Robert W. Scully, PE  
Supervising Sanitary Engineer  
Environmental Engineering Program  
CT Dept. of Public Health

RE: Comments on CT DOH Leaching System Ratings

Figure 1: US EPA Onsite Wastewater Treatment Systems Manual, 2002

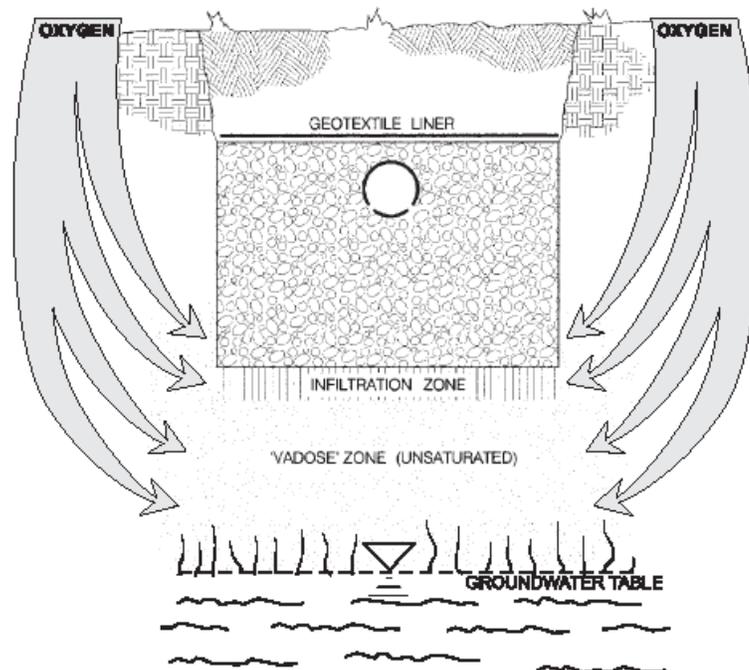
4. Trench center-to-center spacing and the relation to internal sidewall competing biomat: These two items: trench spacing and competing biomat are really the same issue. Trench spacing is provided to allow for oxygen diffusion (see figure 1 from US EPA attached) to the trench. Why an internal surface is allowed to be only inches away and yet an

adjoining trench has to be many feet away makes no sense (scientifically). Hence the internal geometry should be discounted from receiving credit.
